# **PRELIMINARY & FINAL DRAINAGE REPORT**

## **ABERT RANCH SUBDIVISION**

March 27, 2017  
Revised November 16, 2017  
Revised April 5, 2019  
Revised November 15, 2019

**JPS Project No. 111604  
PCD File No. SP-17-007**

SHEET: **EX1**

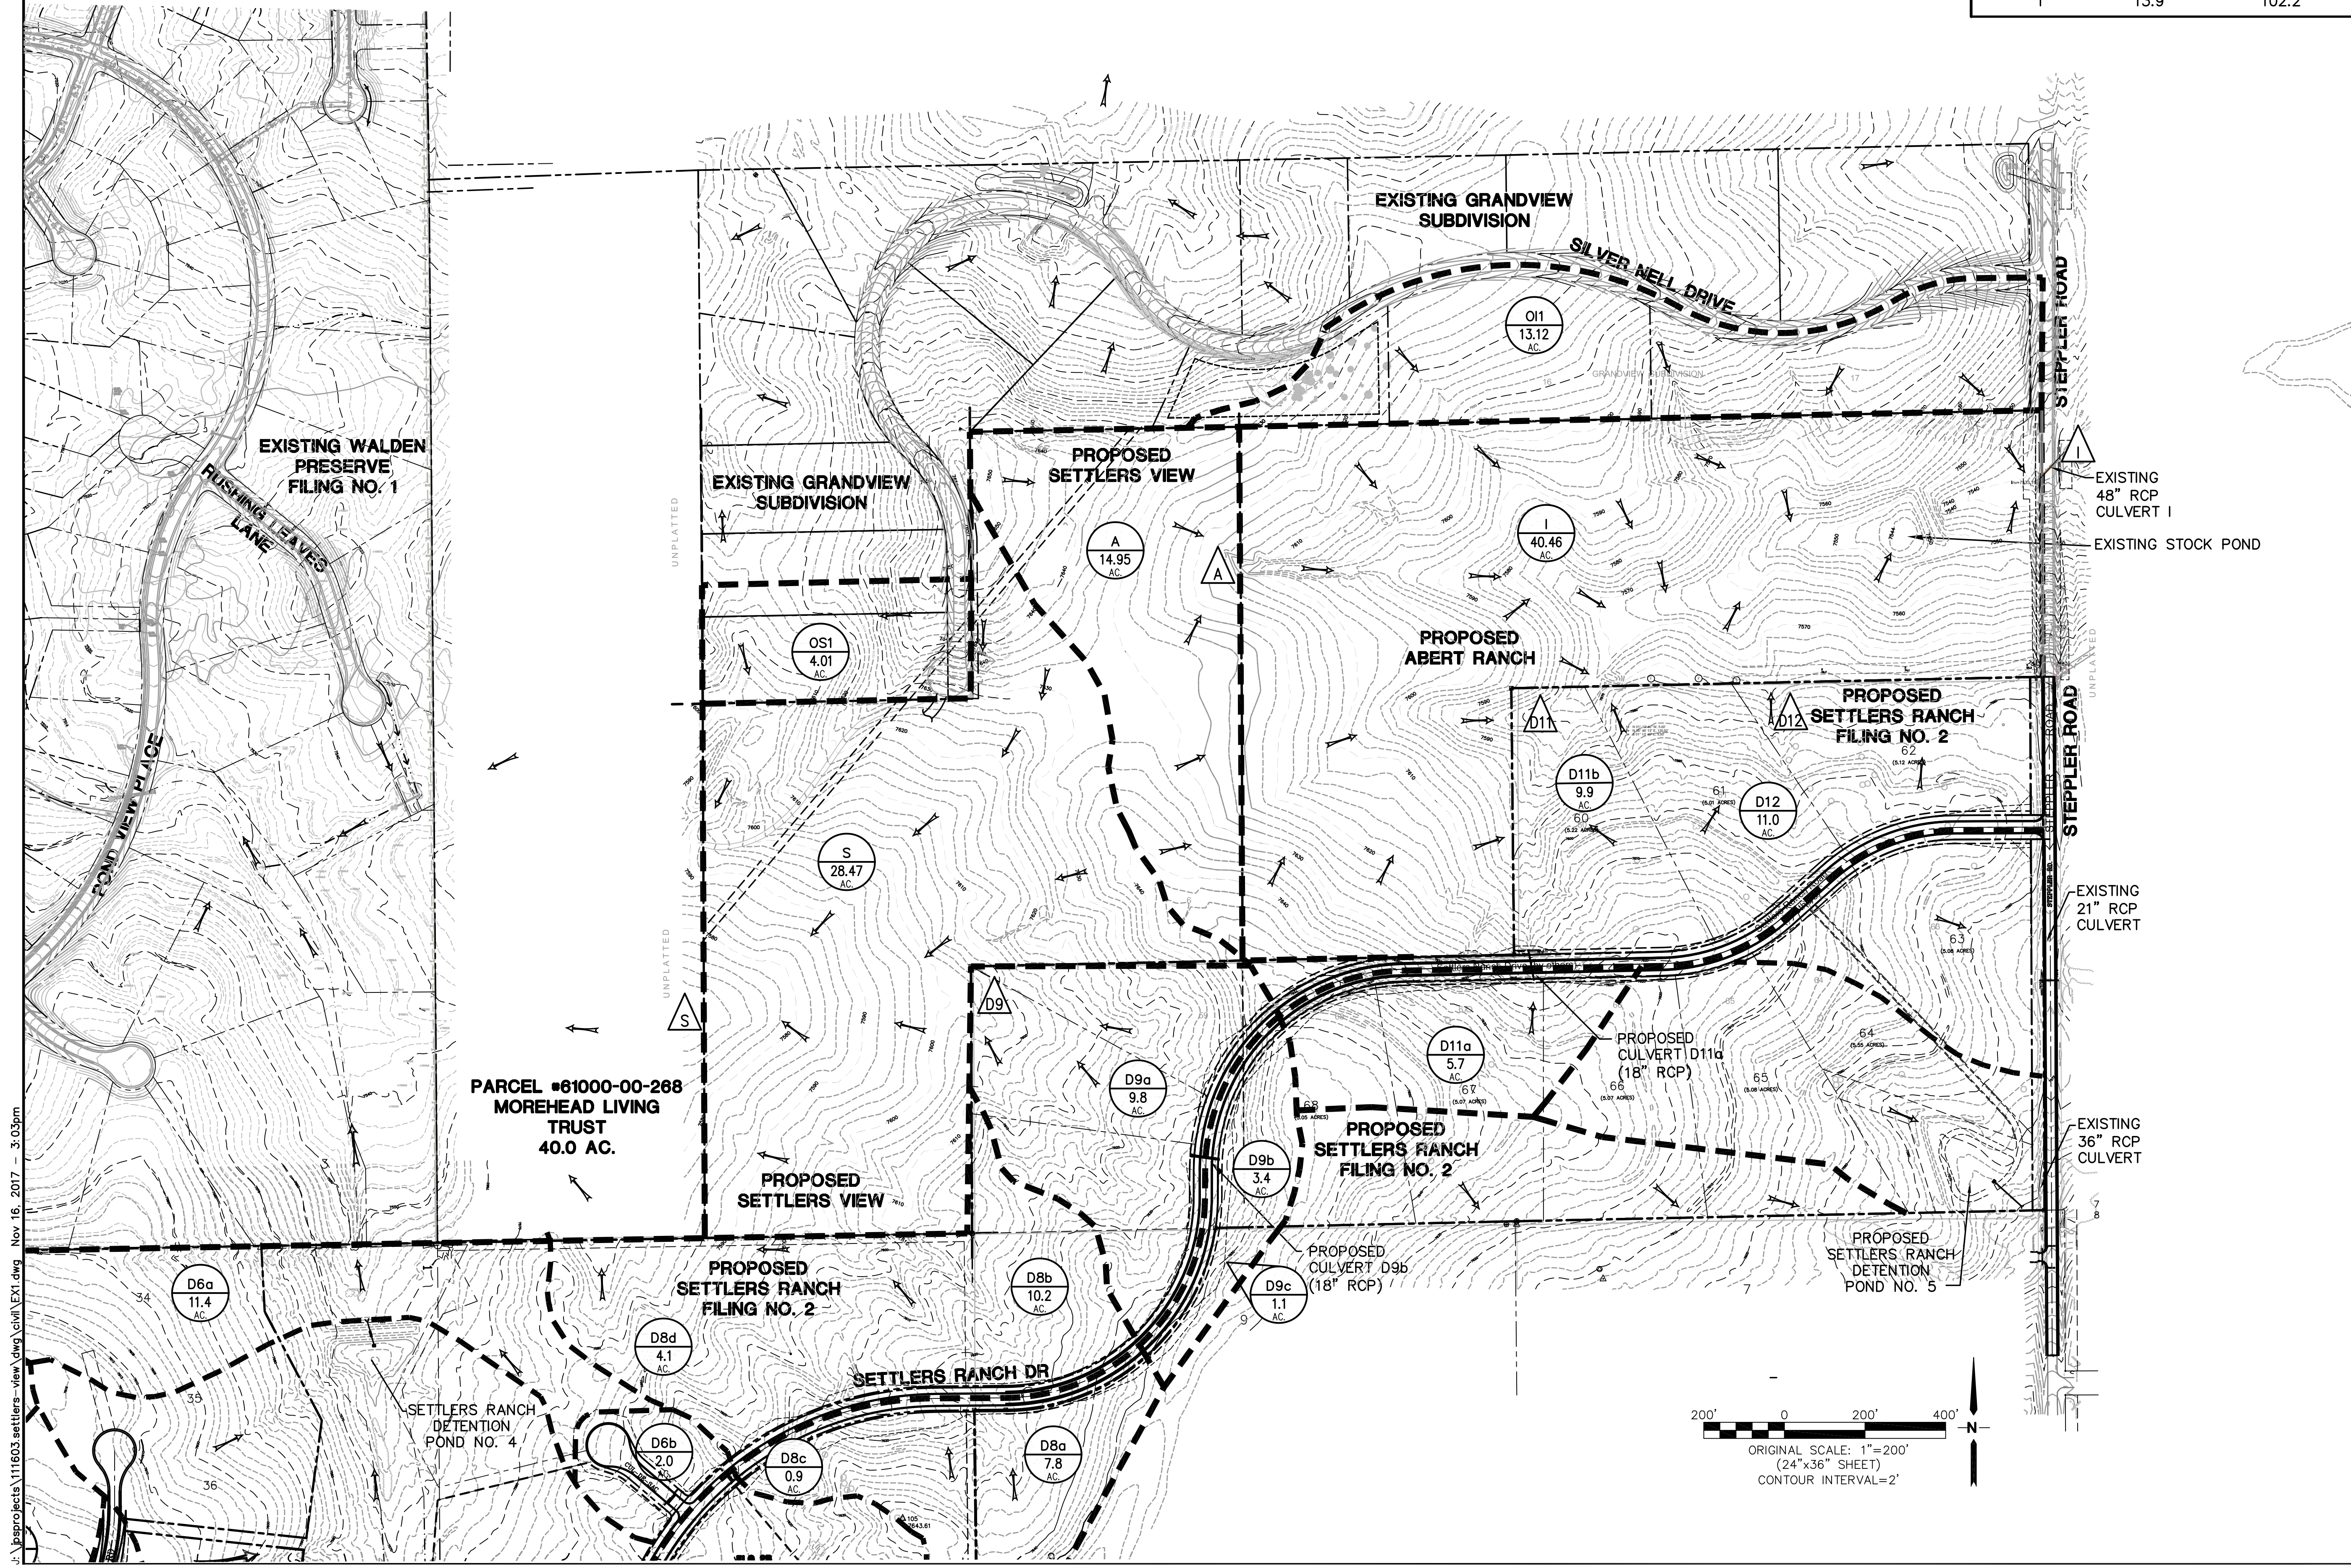
In comparing the historic (102.2 cfs) to detained flow, the detained flow is still greater than historic. The percentage increases. Please revise accordingly.

SHEET: **D1.1**

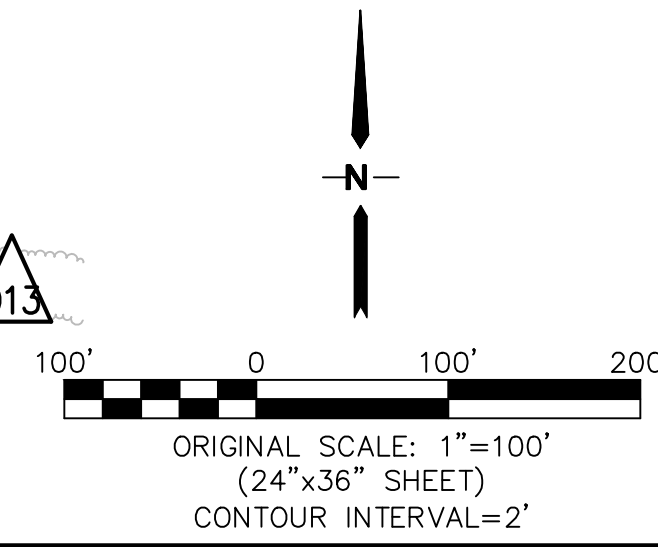
The plat identifies a 36' drainage easement. Please verify all drainage easements and coordinate so that they match.

The channel analysis calculation indicates channel A as triangular. Please revise accordingly.

Please revise as the hydraulic calculation indicates this as a triangular channel not a trapezoidal channel

per the design calculations the top width of the channel is 42.86 ft. Please revise the drainage easement width to contain the top width (100yr flow). Note that the CD's indicate a 45' wide drainage and access easement.
